From: Mess, Camie
Sent: Thursday, December 21, 2017 11:44 AM
To: 'jamesrobertson81@gmail.com'
Subject: BAR Action- December 19, 2017 - 714 Locust Ave

Certificate of Appropriateness Application (Historic Conservation District)
BAR 17-12-01
714 Locust Avenue
Tax Parcel 510069000
Rashad Dacus, Owner/James Robertson, Applicant
Additional front porch and landscaping

**CITY OF CHARLOTTESVILLE
BOARD OF ARCHITECTURAL REVIEW
STAFF REPORT
December 19, 2017**

BAR 17-12-01

Dacus Residence - 29 August 2017 - 1/4" = 1'-0"

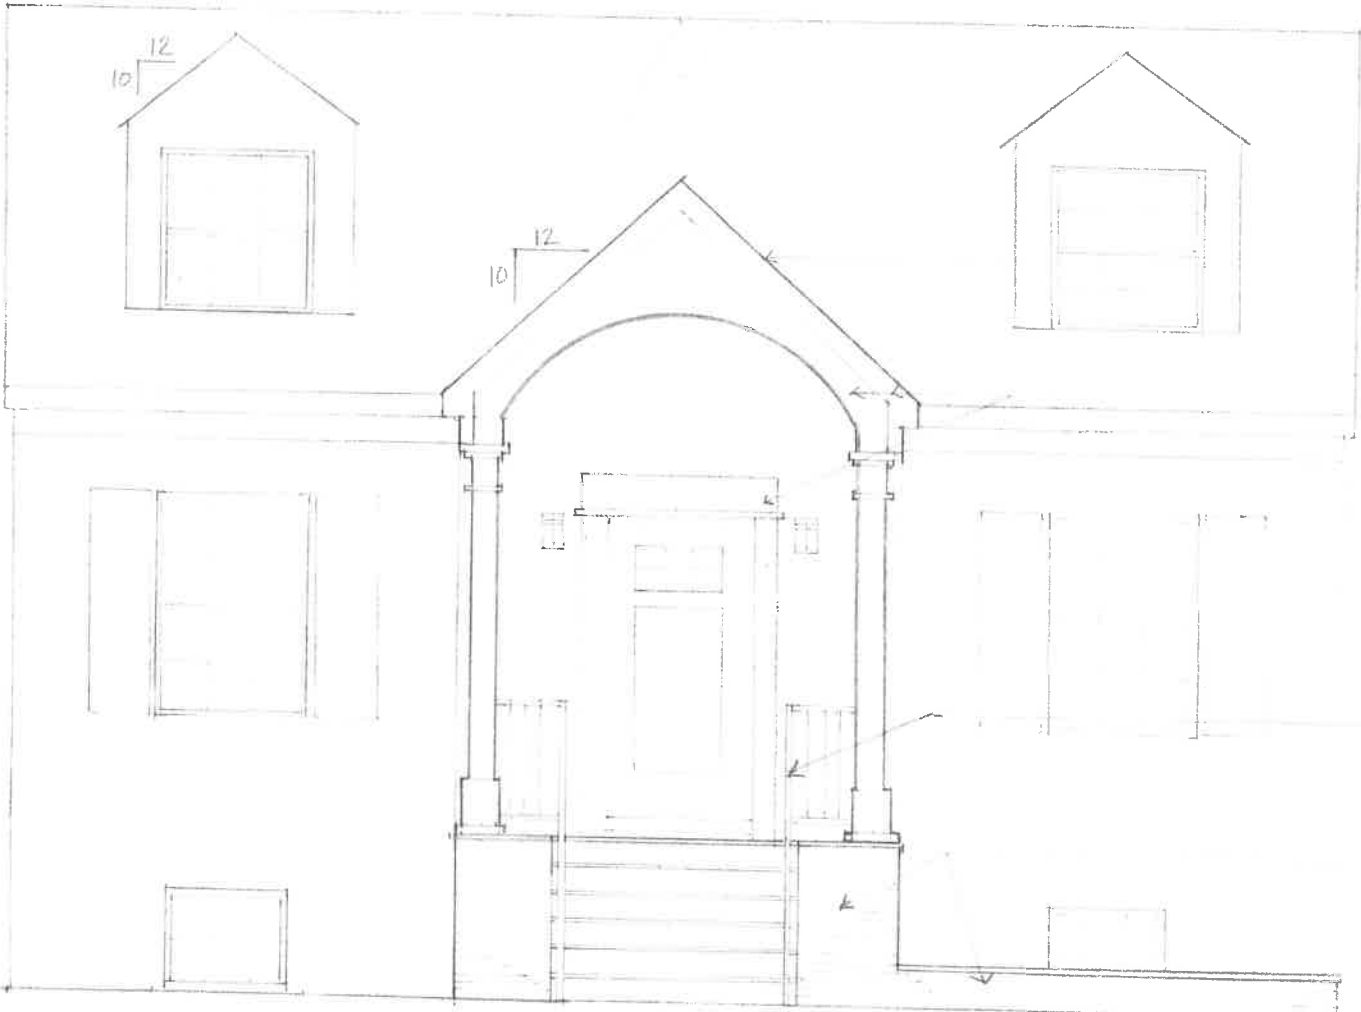
Mohr moved: Having considered the standards set forth within the City Code, including Historic Conservation District Guidelines for New Construction and Additions, I move to find that the proposed front porch roof addition does not satisfy the BAR's criteria and is not compatible with this property and other properties in the Martha Jefferson Historic Conservation District, because the porch roof addition covers the primary front gable which is a character defining feature of the house and that the BAR denies the porch roof addition as submitted.

Also, Mohr moved to find that the material changes to the stoop, stairs, and proposed garden wall satisfy the BAR's criteria and are compatible with this property and other properties in the Martha Jefferson Historic Conservation District and that the BAR approves that part of the application with these modifications:

- **The materials for the stoop, stairs, and garden wall meet the BAR's Guidelines**
- **The stoop must be held back a minimum of 8 inches on both sides from the existing brick central bay**
- **The proposed porch roof is denied, but the applicant may submit an alternate design to the BAR for a smaller canopy (with a submission to come back to the BAR to review)**
- **The BAR suggests the applicant retain the existing trim and door, and look into light fixtures that are in keeping with the current style.**

In staff's opinion while the scale and materials of the proposed porch are appropriate to the building and within this conservation district, the issue is whether the addition impacts the essential architectural form and integrity of the building. The central bay gable with the three small circular holes punched at the top in a triangular pattern is a character defining feature of the house.

Because this is in a historic conservation district rather than an ADC district, the BAR has fewer guidelines to consider. The BAR should confirm the material of the new trim, and determine if the style of the proposed door and sconces are compatible with the Minimal Tudor style of the house. The composite material of the columns should be paintable.

- The dormers look like they may have been added later. Do you think that is the case? And have they considered adding a bit of an overhang between the dormers' roof and the front of each dormer? Even a small one?
- The lights and front door appear to be prairie style. Do you think they would consider styling them more in keeping with the design of the house?
